ISSUE: Permit to Demolish/Capsulate (partial) and Certificate of Appropriateness for alterations.

LOCATION: Old and Historic Alexandria District
115 South Washington Street

BAR #2022-00136 and BAR #2022-00137
115 South Washington Street

2 DEMO REAR ELEVATION
1/8"=1'-0"

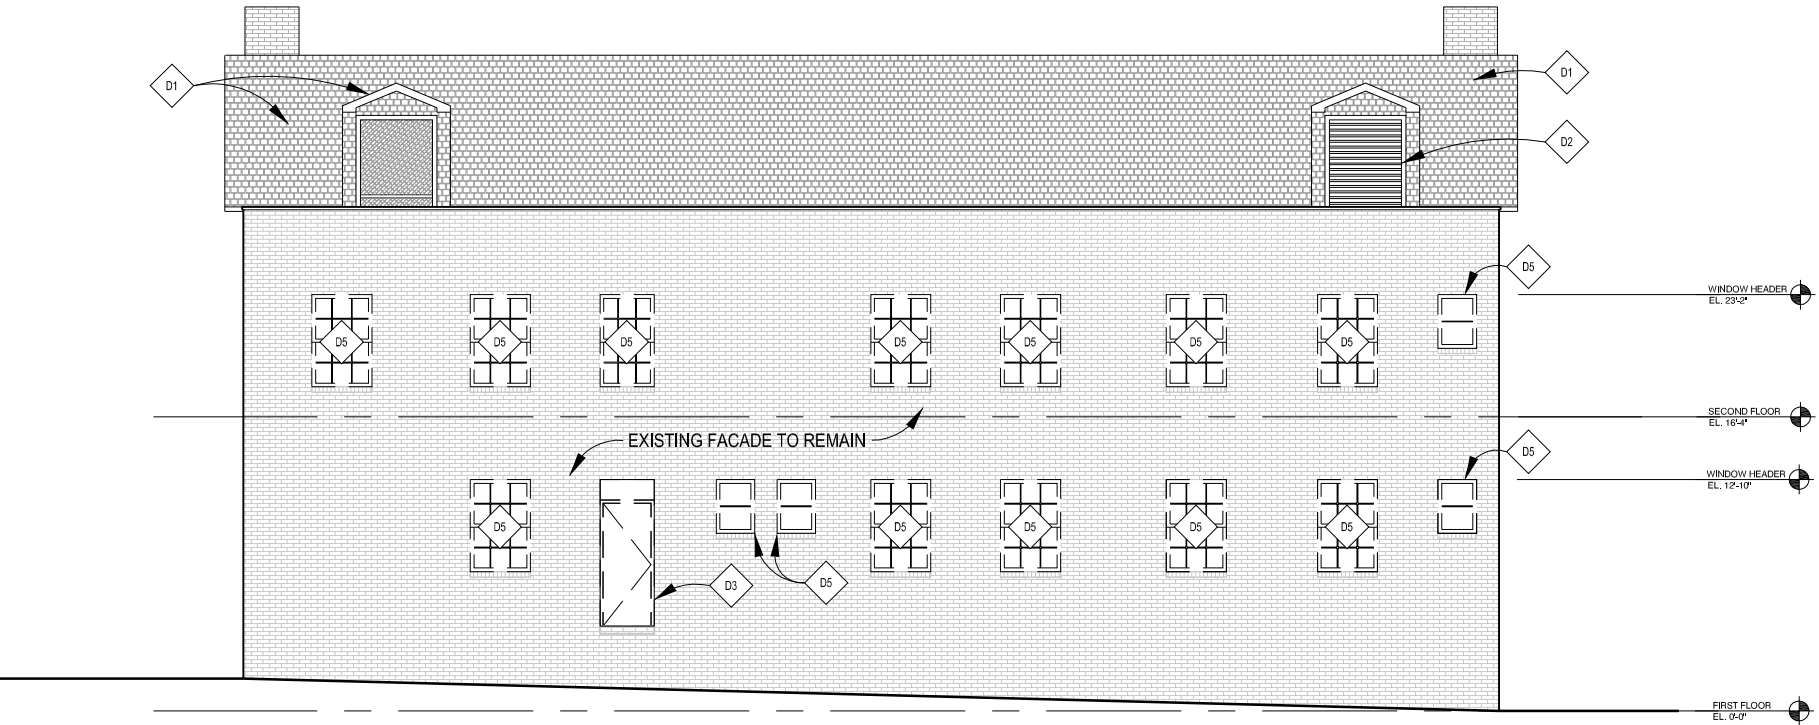
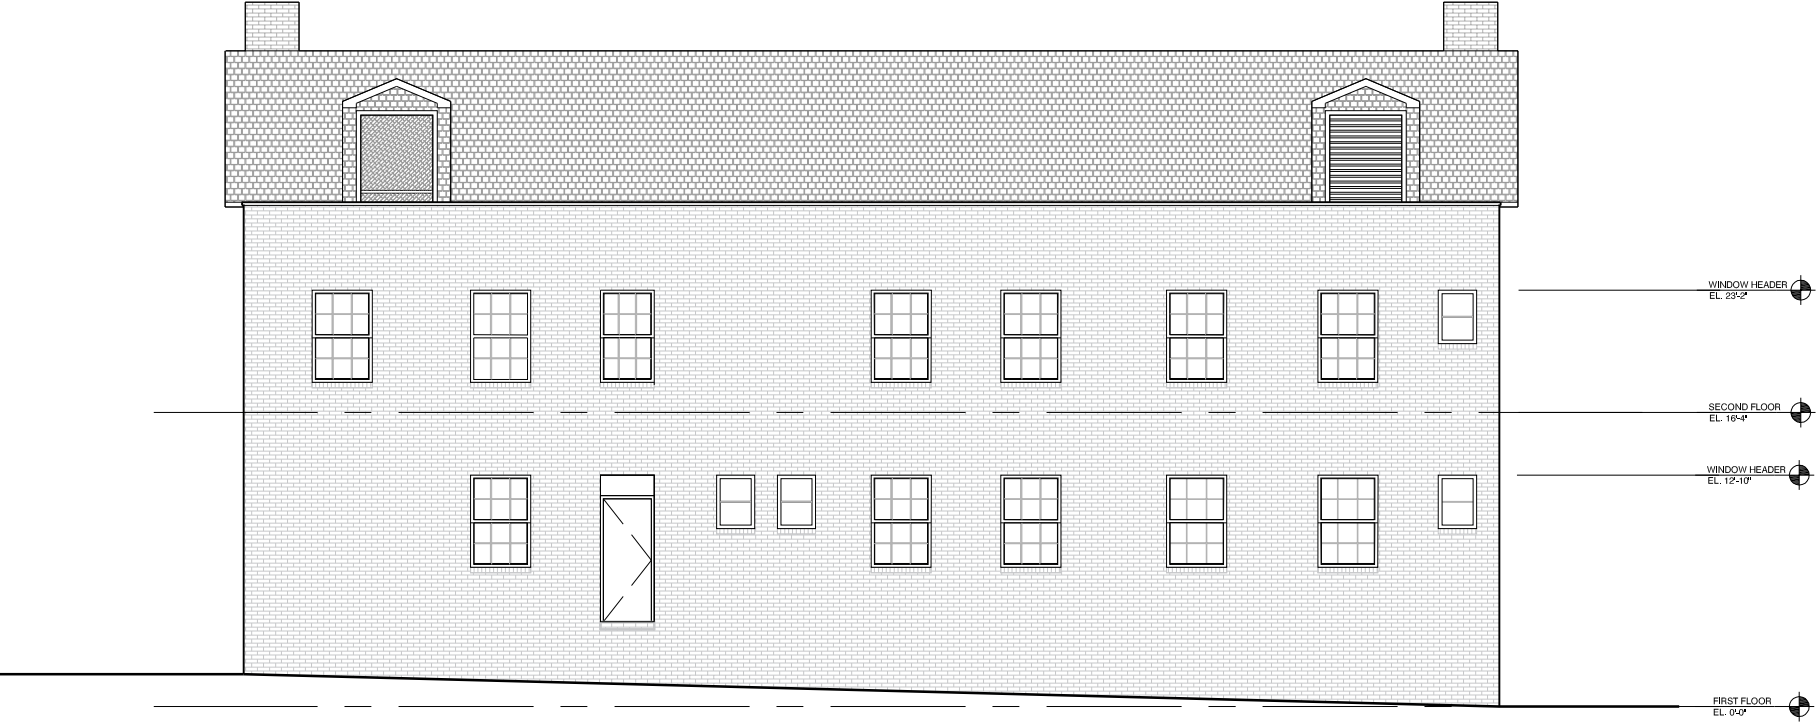
1. The applicant must submit updated window specifications that comply with the *Alexandria New and Replacement Window Performance Specifications* with the building permit application; and,
2. The mortar used for the infill area must match the mortar color and texture, as well as the joint profile of the existing elevation.

In the opinion of staff, none of the criteria for demolition and capsulation are met and the Permit to Demolish/Capsulate should be granted. The proposed amount of demolition is limited to approximately 237 square feet of wall area. The elevations are minimally visible, and not of unusual or uncommon design. Staff supports the proposed Permit to Demolish with the condition that the mortar used for the infill area matches the mortar color and texture, as well as the joint profile of the existing elevation.

1 ALLEY SIDE ELEVATION
1/8"=1'-0"

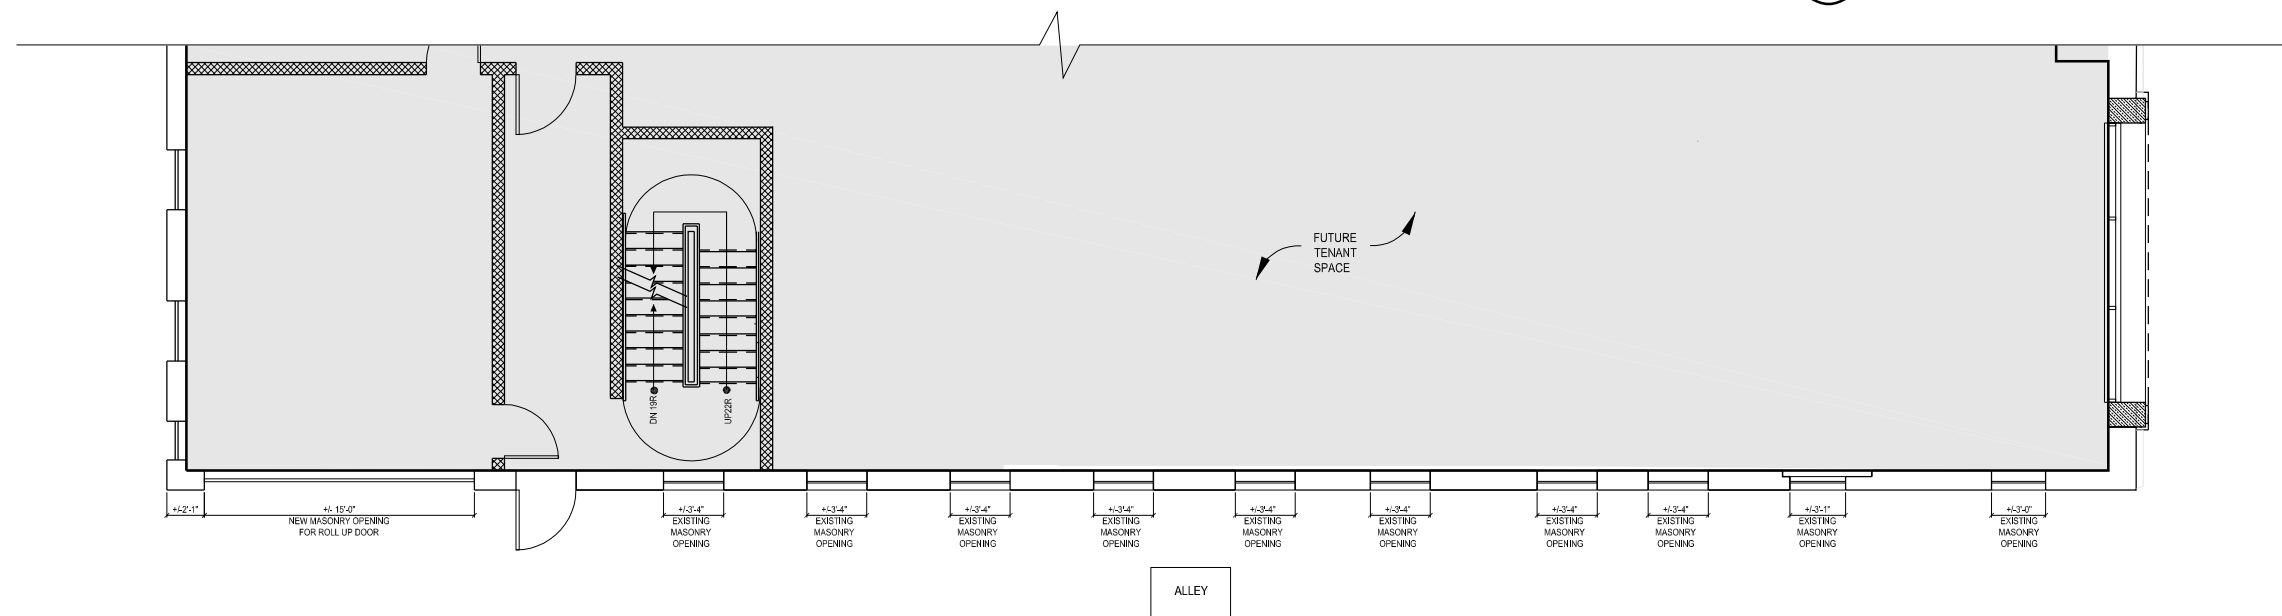
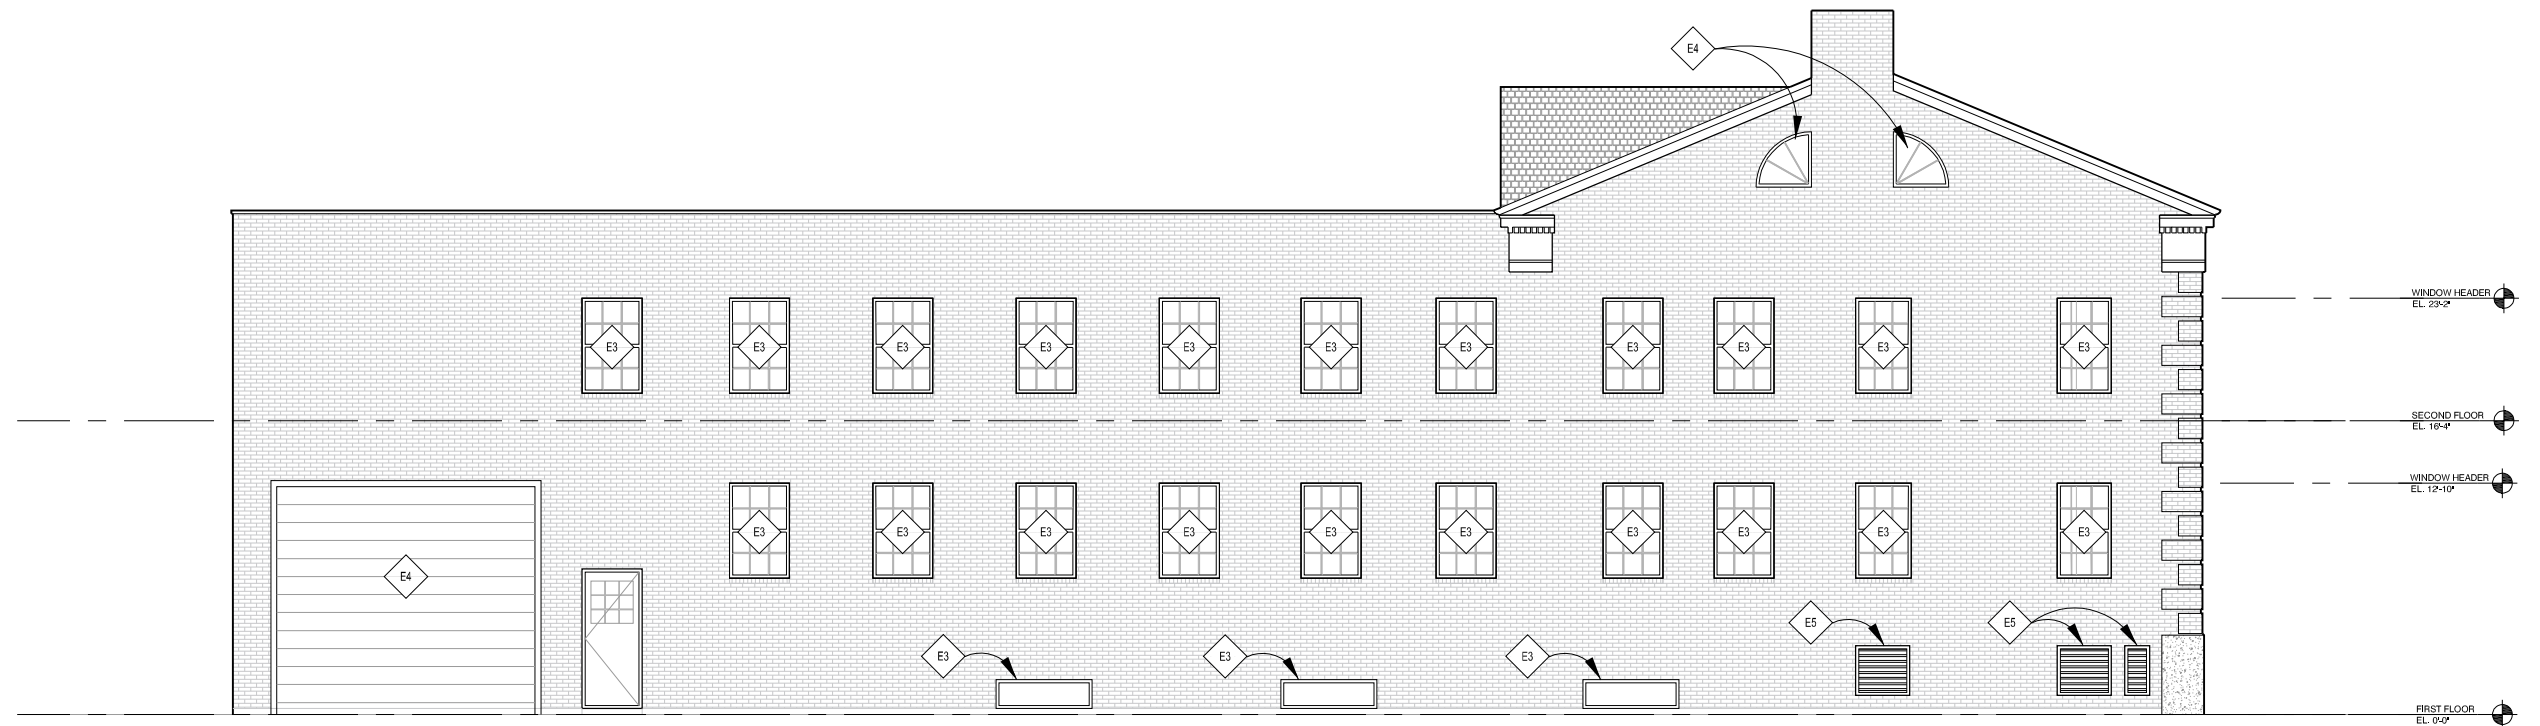
Staff also supports the construction of the rolling loading dock door. The 15’ wide door will be located in the south (alley) elevation and minimally visible from the South Washington Street. Additionally, this door type is typical for retail uses and will be installed on an appropriate secondary elevation. It will not detract from the architectural character of the building.
